RECORD DWGS
AS FABRICATED
6/24/13

TOWN OF WARREN, VT
COUNTY OF WASHINGTON
BRIDGE NO.173 REPLACEMENT
WARREN, VT

ITEM NO.:
PROJECT NO.: BRF 013-4 (14)
REFERENCE NO.:
BRIDGE NO.: 173
STRUCTURAL FILE NO.:

DESIGN: SAF	DRAW: TLB	REVIEW: SAF/RLI	CHECK: CJG	DATE: 6/24/13
SHOP DETAILS		SHOP ASSEMBLY		JOB# 8a
			USB JOB# 51622	58

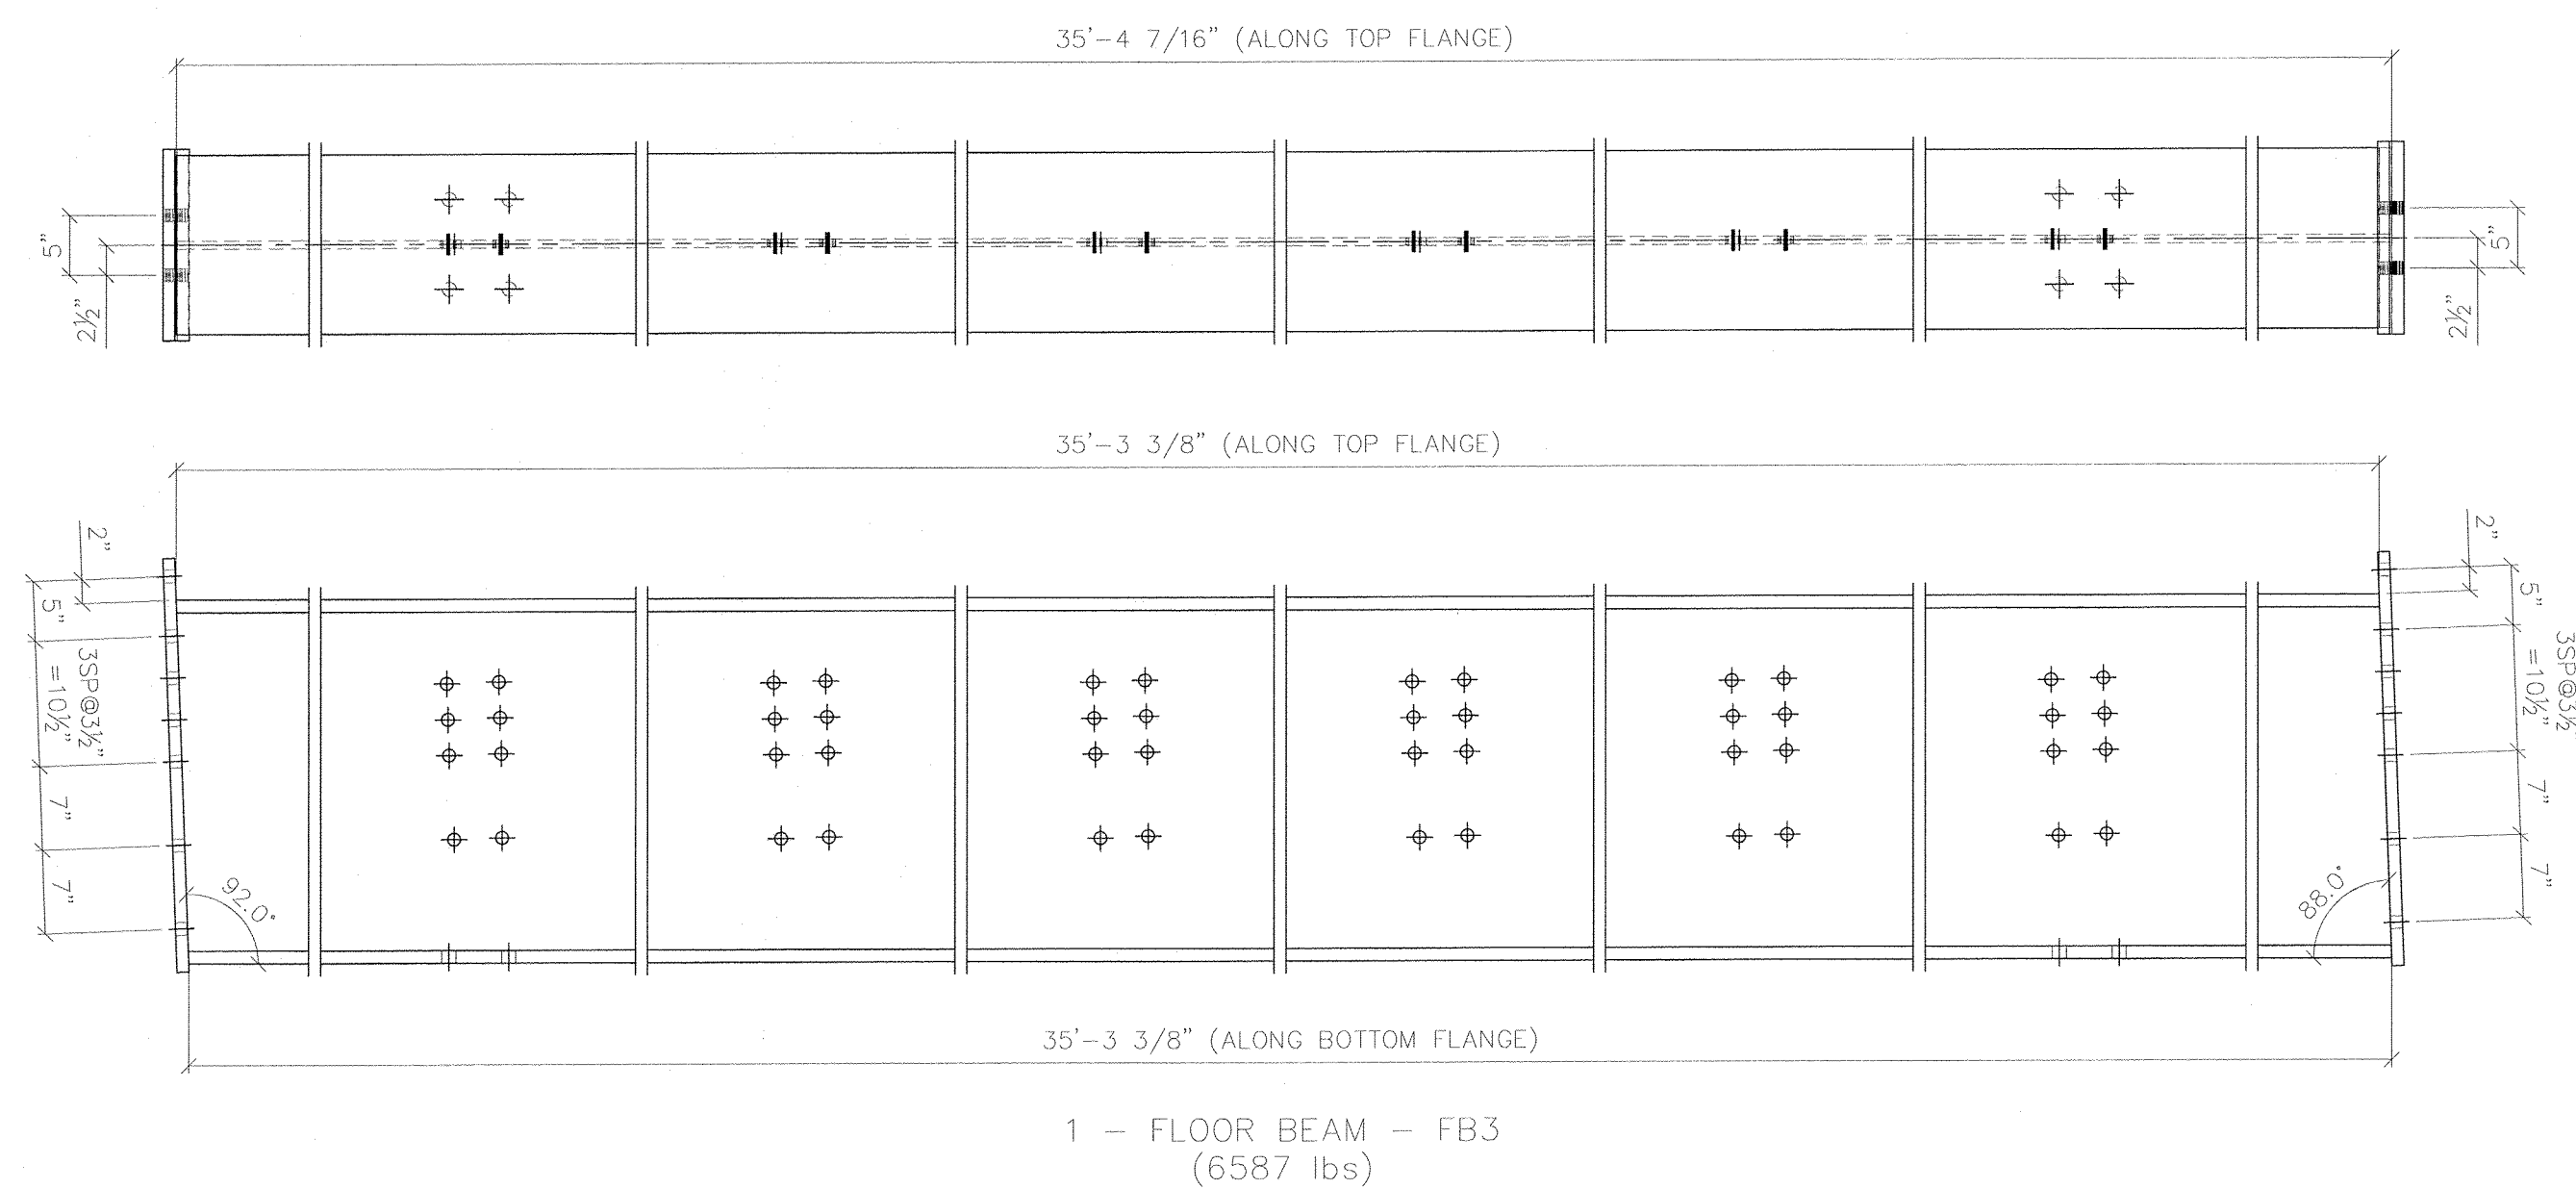
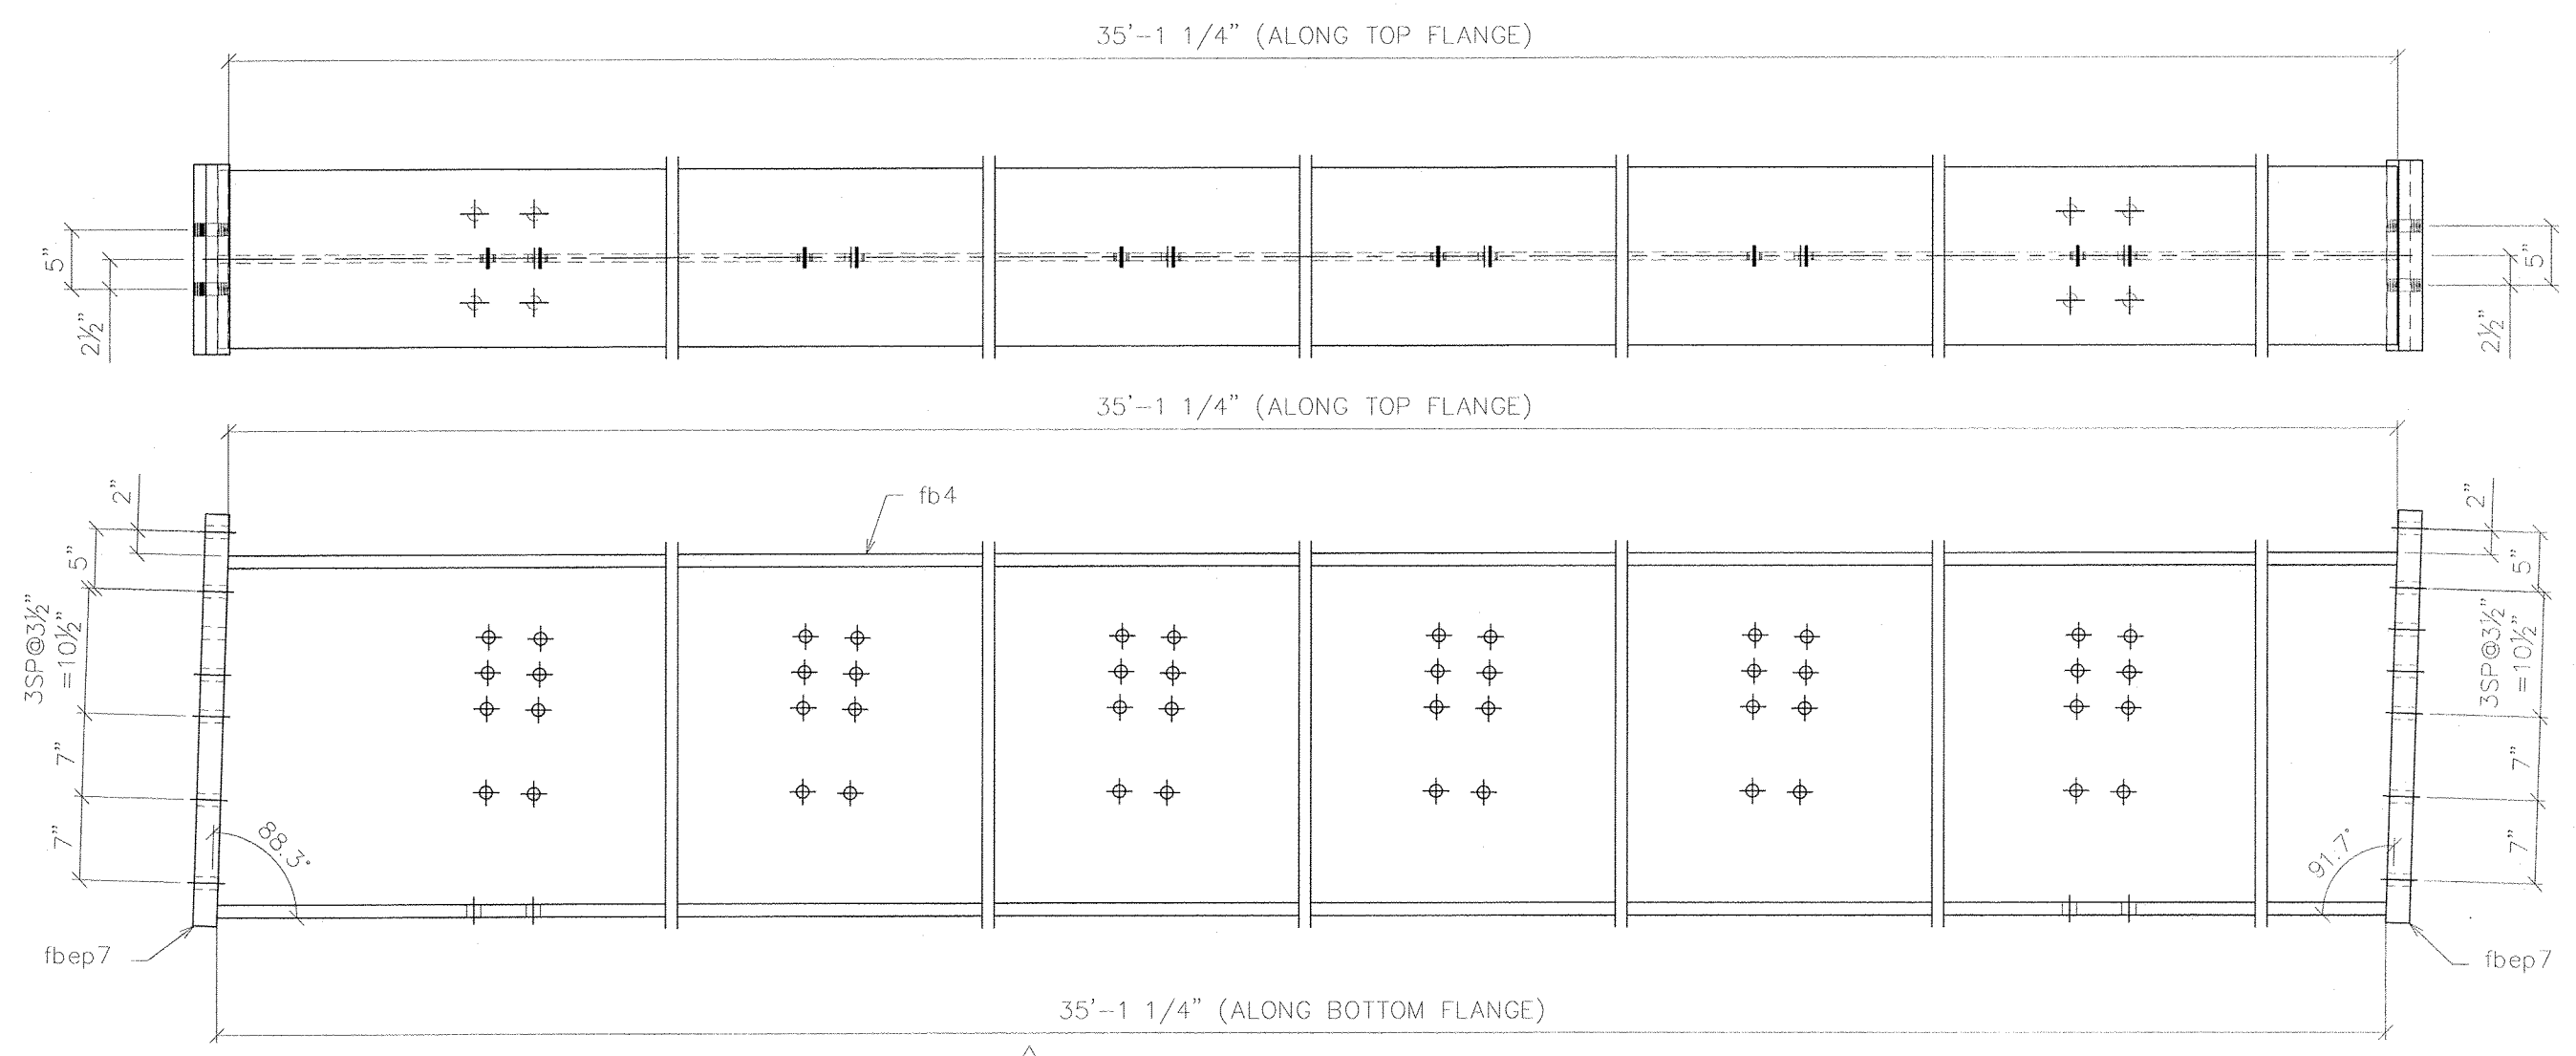
SUBMITTAL LOG	DATE	NO.	DATE	REVISIONS	BY
INITIAL SUBMITTAL	12/18/12	1	5/15/13	FLOOR BEAM END PLATES WAS 1" THK	TLB
RESUBMITTAL NO. 2	2/6/13	2	5/15/13	ADDED 2" DIA. RAT HOLES IN fb1 & fb9	TLB
CUSTOMER APPROVAL	2/13/13	3	5/15/13	CHANGED WELD WAS 3/8" ALL AROUND	TLB
SHOP REVIEW	-	4	5/15/13	CHANGED BOLT PATTERN	TLB
PRE FAB MTG	-	5	5/15/13	WAS 2" EDGE DISTANCE	TLB
APPROVED FOR FAB	2/28/13	6	6/3/13	DIMENSIONAL ERRORS	TLB
